# Access Compliance Report

## Public Rights-of-Way

### (Pedestrian Signals)

Intersection ID: N/A	Main Street:	Cross Street: N/A	Location: N/A
ADA ID: 08D62DCAD8F0	Signal Type: One Push Button-Non APS	Overall Compliance: No	Severity Score: BTN 1: N/A BTN 2: N/A No BTN: N/A
Codes/Mitigation Info/Possible Solution		Field Measurements/Component Compliance

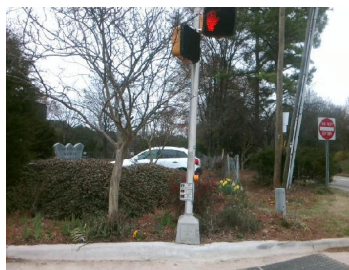
PROW/ADA: R404.7.2

N/A	B 1 FWD Approach Width (in)	N/A	N/A	B 2 FWD Approach Width (in)	N/A
N/A	B 1 FWD Approach Obstruction?	Yes	N/A	B 2 FWD Approach Obstruction?	N/A
N/A	B 1 FWD Approach Obstruction Dist (in)	2.0	N/A	B 2 FWD Approach ObstructionDist (in)	N/A
N/A	B 1 PARA Approach?	Yes	N/A	B 2 PARA Approach?	N/A
N/A	B 1 PARA Approach Constrained?	Yes	N/A	B 2 PARA Approach Constrained?	N/A
Yes	B 1 PARA Approach Reach (in)	10.0	N/A	B 2 PARA Approach Reach (in)	N/A
No	B 1 PARA Approach Width (in)	48.0	N/A	B 2 PARA Approach Width (in)	N/A
N/A	B 1 PARA Approach Obstruction?	Yes	N/A	B 2 PARA Approach Obstruction?	N/A
N/A	B 1 PARA Approach Obstruction Dist (in)	2.0	N/A	B 2 PARA Approach ObstructionDist (in)	N/A
Yes	B 1 Clear Floor Space Slope (%)	1.0	N/A	B 2 Clear Floor Space Slope (%)	N/A
Yes	B 1 Clear Floor Space XSlope (%)	0.2	N/A	B 2 Clear Floor Space XSlope (%)	N/A
N/A	B 1 PAR Slope (%)	N/A	N/A	B 2 PAR Slope (%)	N/A
Yes	B 1 Height (in)	42.0	N/A	B 2 Height (in)	N/A

Possible Solutions: Remove and Replace Clear Space.
